PROPOSED TECHNICAL SPECIFICATION CHANGES
REGARDING MINIMUM CRITICAL POWER RATIO SAFETY LIMIT

JAMES A. FITZPATRICK NUCLEAR POWER PLANT
Docket No. 50-333
DPR-59

**SAFETY EVALUATION FOR
PROPOSED TECHNICAL SPECIFICATION CHANGES
REGARDING MINIMUM CRITICAL POWER RATIO SAFETY LIMIT**

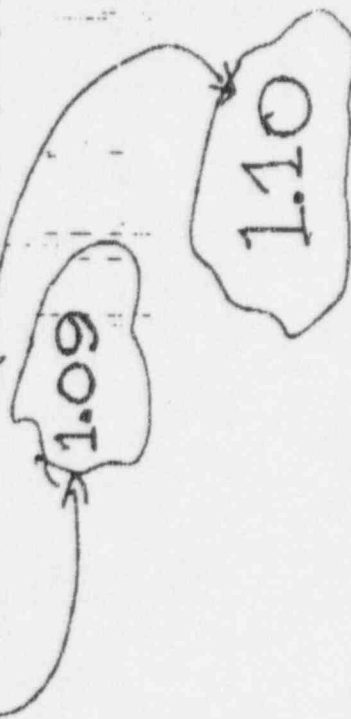
Change "1.07" in specification 1.1.A to "1.09." Change "1.08" in specification 1.1.A to "1.10."

The existence of a minimum critical power ratio (MCPR) less than 1.07 shall constitute violation of the fuel cladding integrity safety limit, hereafter called the Safety Limit. An MCPR Safety Limit of 1.08 shall apply during single-loop operation.

[The existence of a minimum critical power ratio (MCPR) less than 1.09 shall constitute violation of the fuel cladding integrity safety limit, hereafter called the Safety Limit. An MCPR Safety Limit of 1.10 shall apply during single-loop operation.
